**CEDAR CREEK STREAM AND WETLAND RESTORATION  
PROJECT  
MONITORING REPORT  
MONITORING YEAR 7  
FINAL**

SAMPSON COUNTY, NORTH CAROLINA  
CONTRACT No. 005011 - PROJECT No. 95718  
USACE ACTION ID No. 2012-00389 – NCDWR PROJECT No. 2013-0186

RE: Cedar Creek Stream and Wetland Restoration Project: MY7 Monitoring Report  
(NCDMS ID 95718)

Listed below are comments provided by DMS on January 11, 2022 regarding the Cedar Creek Stream and Wetland Restoration Project: Year 7 Monitoring Report and RES' responses.

# MY7 2021 Cedar Creek ACG2 Flow Gauge

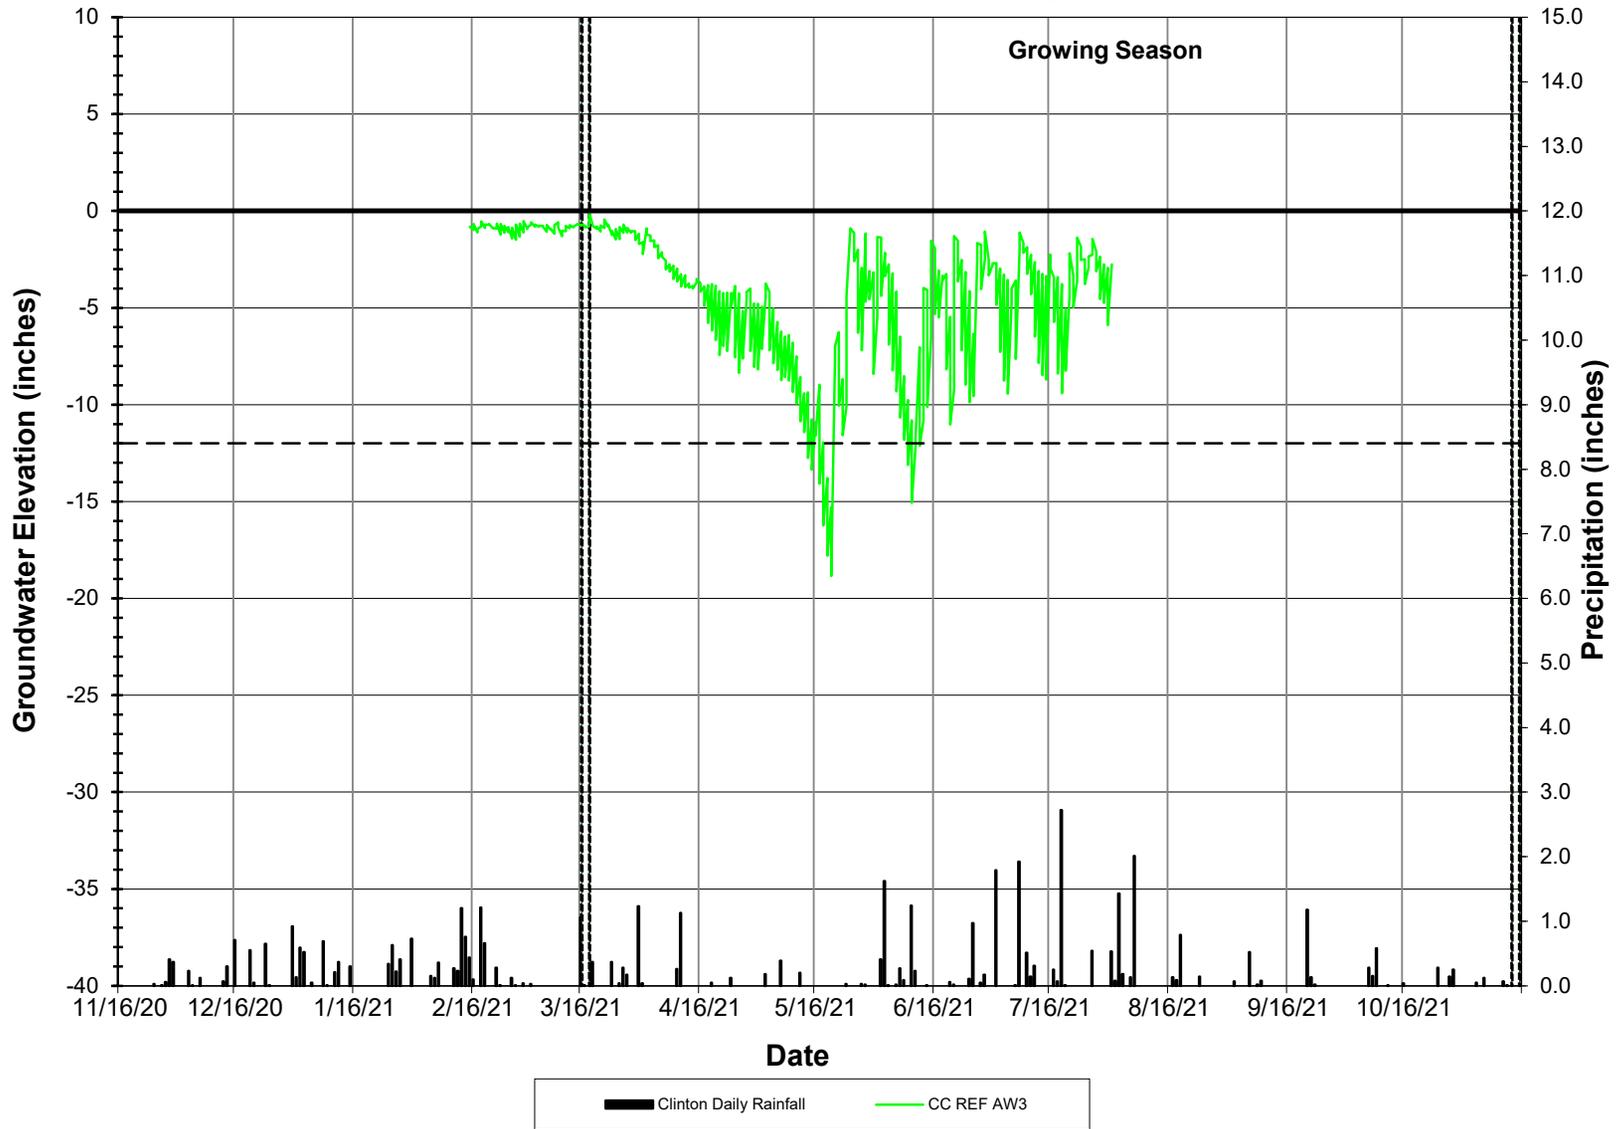
5. Please include the wetland hydrology figures in Appendix E.  
[Done.](#)
6. Ensure that the figure for ACG2 is being displayed correctly. The chart type in excel should be scatter with straight lines.  
[Done.](#)
7. Please submit updated wetland shapefiles with the new area proposed for unrealized credits.  
[Done.](#)
